# Access Compliance Report

## Public Rights-of-Way

### (Curb Ramps)

Intersection ID: 18538	Main Street: SENECA_PL	Cross Street: SOUTH_BV	Location: SE
ADA ID: 1764AA459CFD	Ramp Type: Perp	Initial Pass/Fail: Fail	Overall Compliance: No
Severity Score: 13.75			
Codes/Mitigation Info/Possible Solution		Field Measurements/Component Compliance

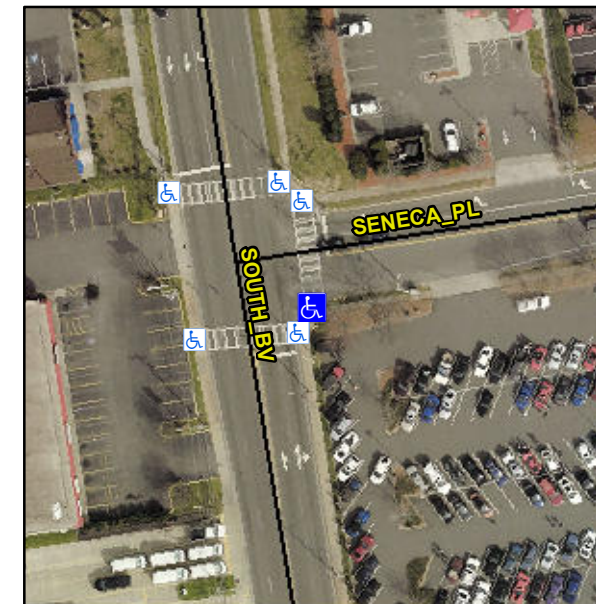
**Not Found, R304.2.2, R304.5.3**

Compliance	Description	Data	Compliance	Description	Data
N/A	Ramp Length (in)	84.0	No	Ramp Slope (%)	10.1
Yes	Ramp Width (in)	48.0	No	Ramp XSlope (%)	3.0
N/A	Flare Type LT	N/A	N/A	Flare Type RT	N/A
N/A	Flare Slope LT (%)	N/A	N/A	Flare Slope RT (%)	N/A
N/A	Flare Traversable LT?	N/A	N/A	Flare Traversable RT?	N/A
N/A	Landing Length (in)	N/A	N/A	DWS Provided?	N/A
N/A	Landing Width (in)	N/A	N/A	DWS Contrast?	N/A
N/A	Landing Slope (%)	N/A	N/A	DWS Length (in)	N/A
N/A	Landing X Slope (%)	N/A	N/A	DWS Full Width?	N/A
N/A	Landing Curb? (Y/N)	N/A	N/A	DWS Offset (in)	N/A
N/A	Shared Landing?	N/A			
N/A	Gutter Ponding?	N/A	N/A	Gutter Slope (%)	N/A
N/A	Gutter Lip Ht (in)	N/A	N/A	Gutter X Slope (%)	N/A
N/A	Painted X Walk1?	Yes	N/A	Painted X Walk2?	N/A
	X Walk 1 Direction	To N		X Walk 2 Direction	N/A
N/A	X Walk 1 Width (in)	114.0	N/A	X Walk 2 Width (in)	N/A
	X Walk 1 Slope (%)	2.9		X Walk 2 Slope (%)	N/A
	X Walk 1 X Slope (%)	2.2		X Walk 2 X Slope (%)	N/A

**Remove & Replace Entire Ramp.**
